MEMORANDUM

SUBJECT: Lake Oswego WTP application (CUP 12-02) and RWP/FWP application (CUP 12-04)

DATE: September 27, 2012

The Lake Oswego Tigard Water Partnership (the Applicant) submitted a land use application for CUP 12-04 on June 25, 2012 and submitted revisions to CUP 12-02 on August 20, 2012. The purpose of this memorandum is to identify changes to the land use application materials that have evolved over the summer as the projects advanced toward 60 percent design completion. This memorandum contains an explanation of the changes made to the application materials for each project and it includes a matrix identifying the changes made to the application materials and the location of the changes within the materials. This memorandum also provides a brief discussion of the combined traffic impacts that will result from construction work associated with CUP 12-02 and CUP 12-04 on Mapleton Drive and Kenthorpe Way.

Figure 1. Combined construction project traffic on Mapleton Drive

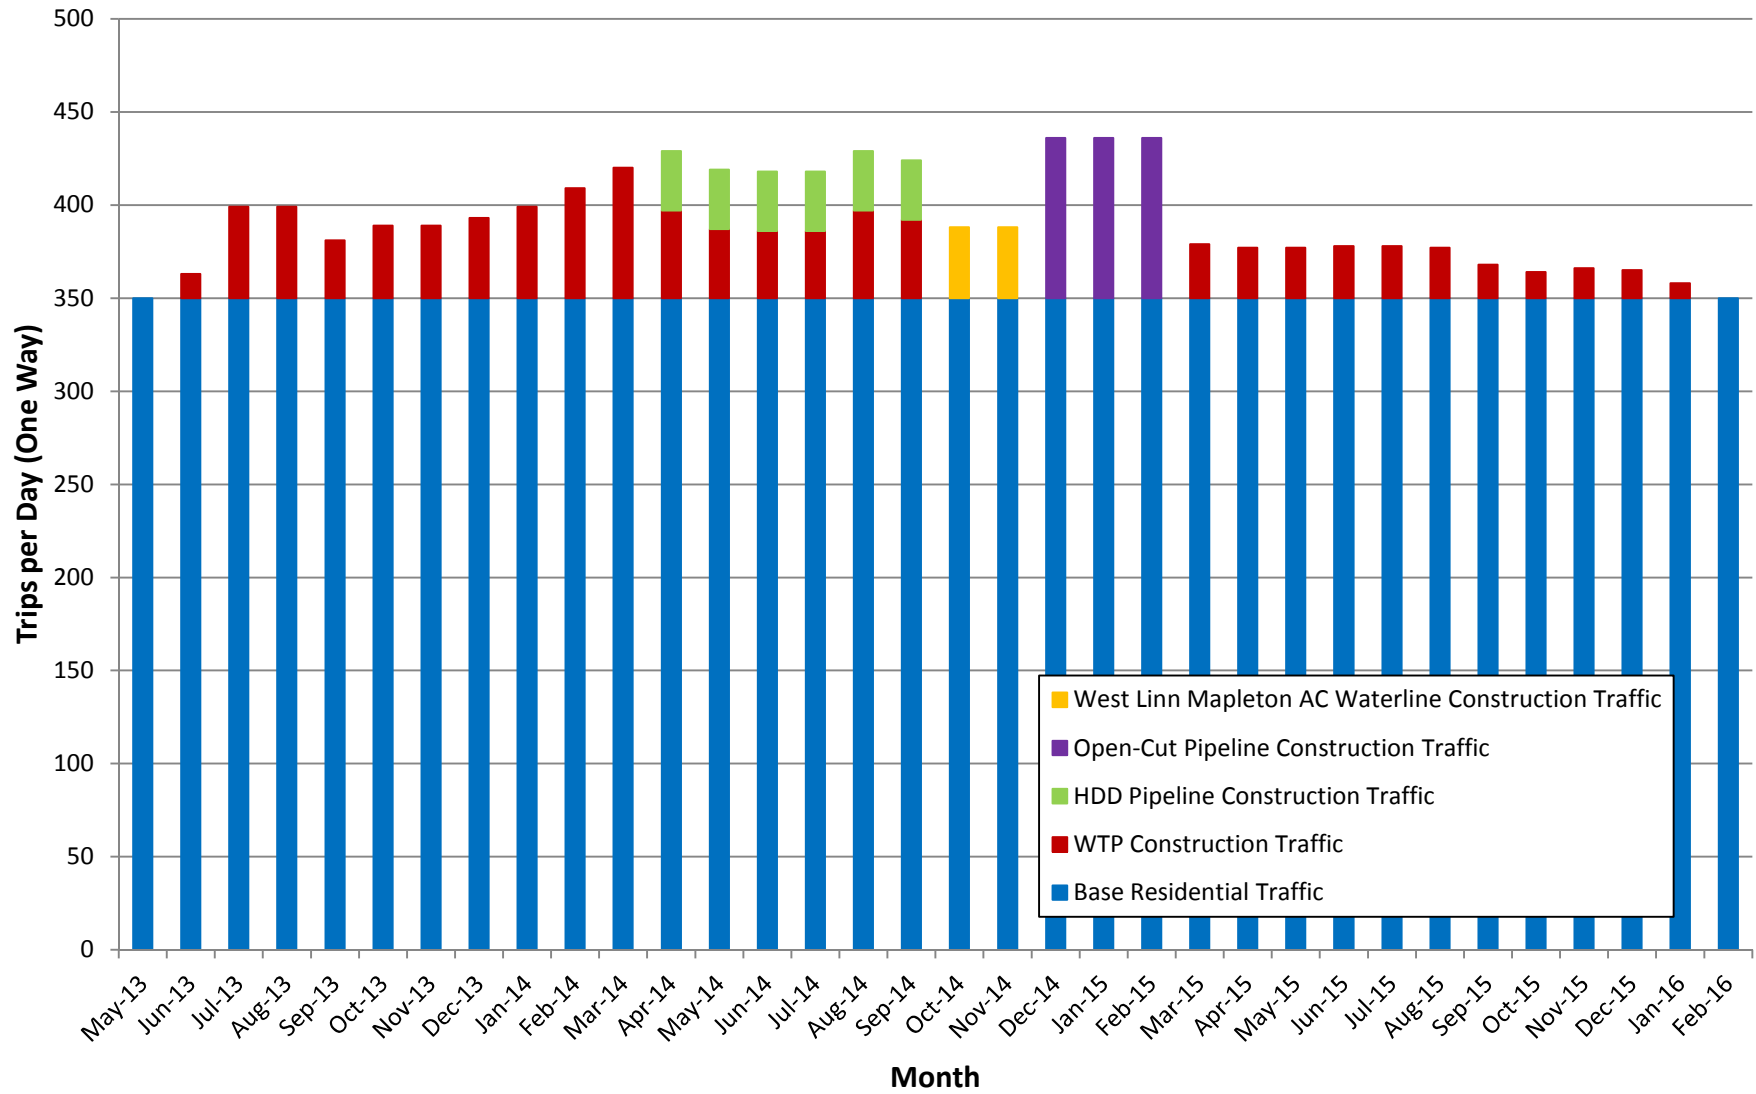
Construction projects associated with both land use applications in West Linn will be sequenced to minimize cumulative traffic impacts. Attached Figures 1 and 2 show sequencing and the combined estimated traffic impacts on both Mapleton Drive and Kenthorpe Way over the 32-month construction duration of the two projects. To minimize traffic volume, WTP construction traffic will generally be evenly split between Mapleton Drive and Kenthorpe Way for most of the project duration. During Mapleton AC waterline replacement and open-cut RWP and FWP pipeline construction activities on Mapleton Drive between October 2014 and March 2015, WTP construction traffic will primarily use Kenthorpe Way to avoid work zone conflicts on Mapleton Drive.

The maximum one-way construction traffic on Mapleton Drive will occur during open-cut construction of the RWP and FWP between November 2014 and March 2015 at 86 trips per day. The maximum one-way construction traffic on Kenthorpe Way will occur during the Mapleton AC waterline replacement as a result of all WTP traffic being routed on Kenthorpe Way and will occur between October and November 2014 with a peak daily volume of 95 trips per day.

CONSTRUCTION TRAILERS EXAMPLE

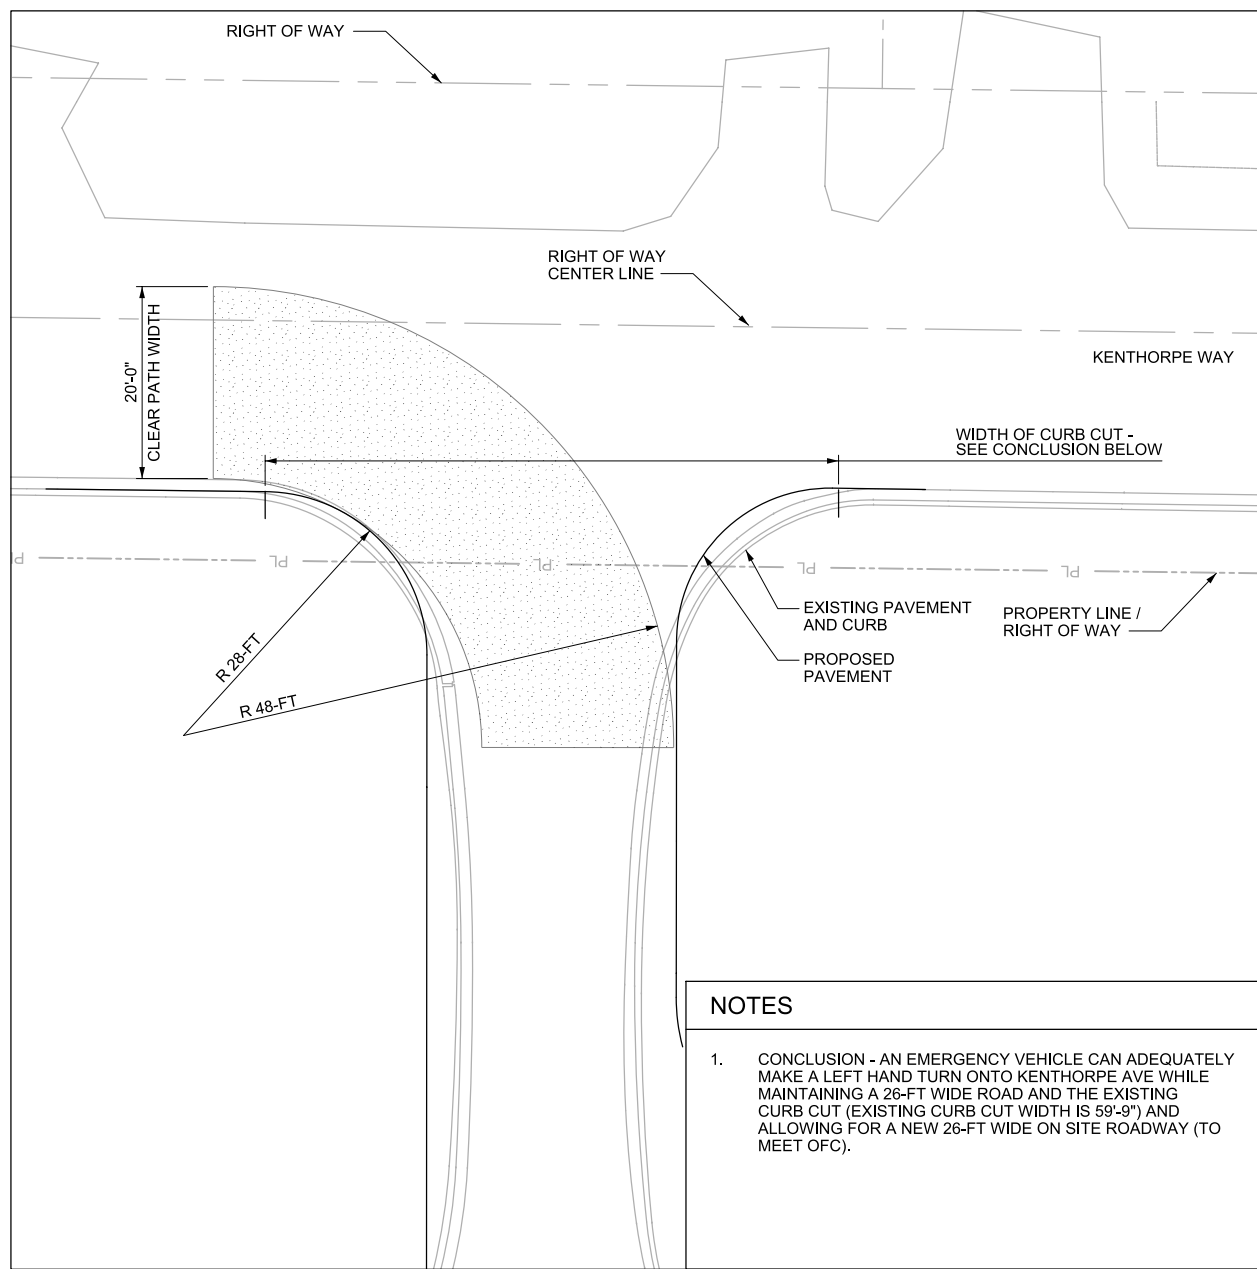
1. Construction Trailers – the Applicant amended the Construction Management Plan (CMP) and Construction Management Overview Figure, Section 21, Figure 6.0, to include information about the location and access of the proposed construction trailer area. Figure 6.0 shows that existing vegetation will provide adequate screening around the proposed construction trailer area. Contractors typically use construction trailers similar to the examples depicted in the attached photograph.

During construction, the contractor will place approximately six to eight construction trailers within the construction trailer area. The designated contractor trailer area is within the construction staging limits, shown in Figure 6.0. The contractor will connect the trailers to electricity, and in some cases, water and sewer.

Action: replace Figure 6.0 of Section 21 and append Section 14A “Construction Management Plan” with the attached Appendix B – Construction Trailer Example.

WEST PLANT ENTRANCE

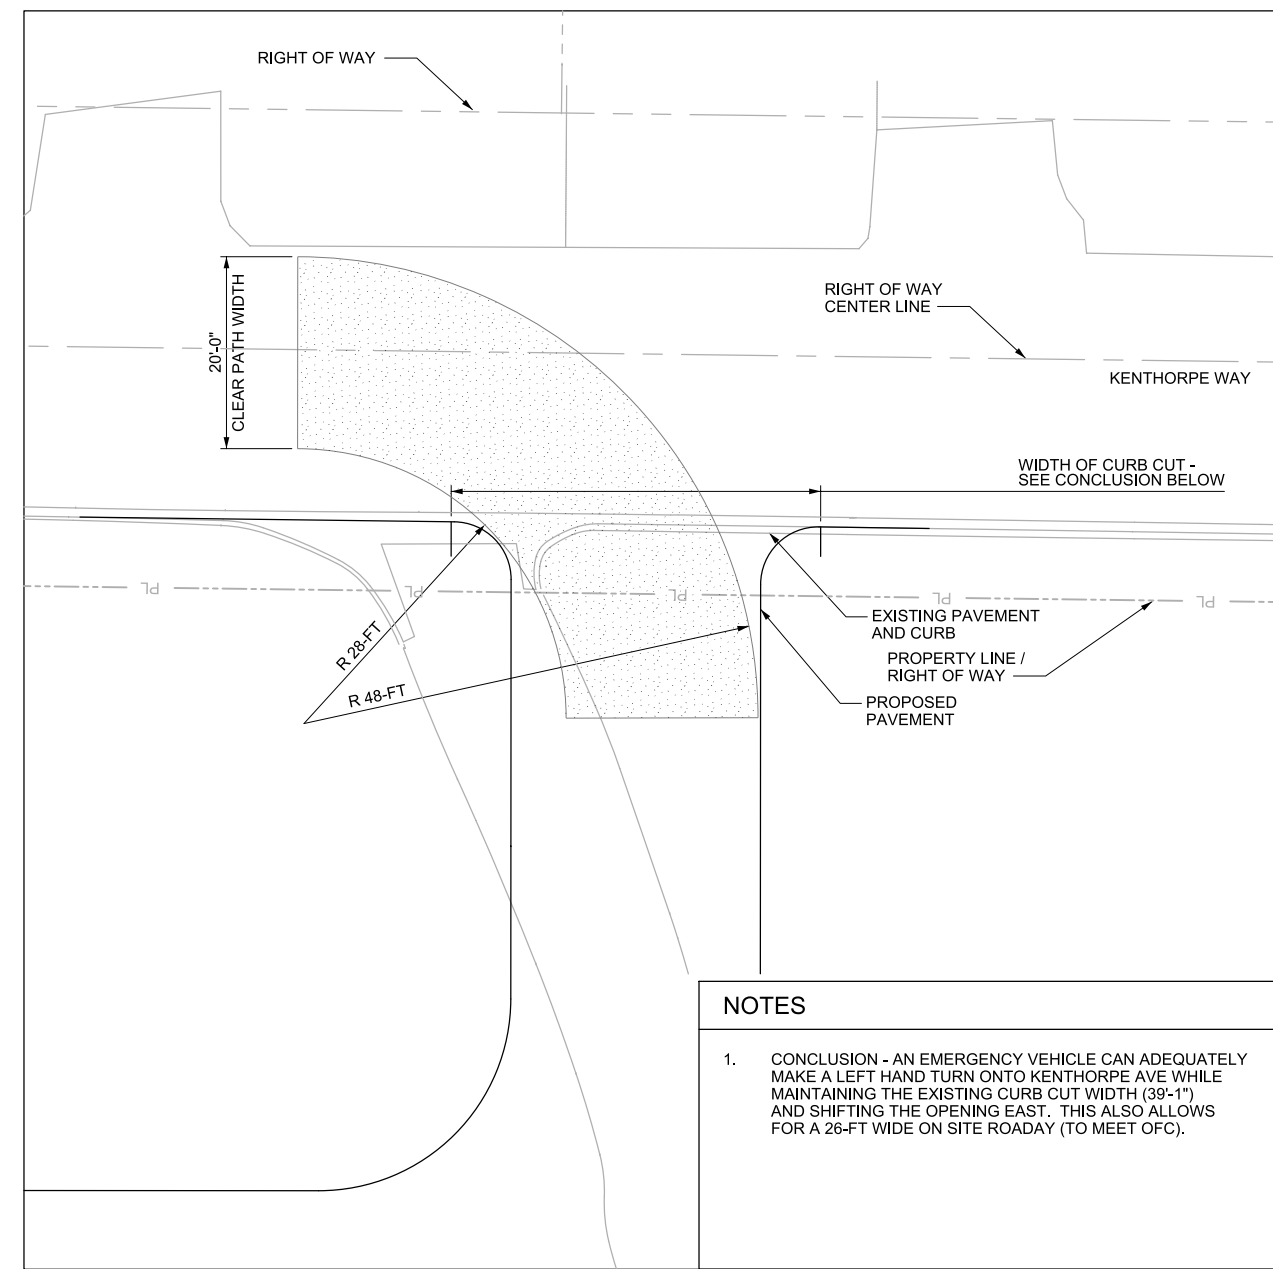
2. Kenthorpe Avenue Entryways – the site plan and application narrative were changed to demonstrate that the existing driveway widths will be maintained and the TVF&R ingress and egress are maintained after construction activity ceases. The site plan the applicant submitted on August 20, 2012 portrayed inaccurate driveway widths on Kenthorpe Way. The existing driveway widths were approved as a nonconforming development in 1997. The applicant will revise all site plans to depict driveway widths of 59'-1" and 39'-1", west and east respectively. The attached “Fire Entrance” figure shows the correct driveway widths.

The same figure also shows the proposed driveway widths and demonstrates that emergency response vehicles have access to the site consistent with the turning radius template provided by TVF&R.

Action: append the attached “Fire Entrance” figure to Section 18A.
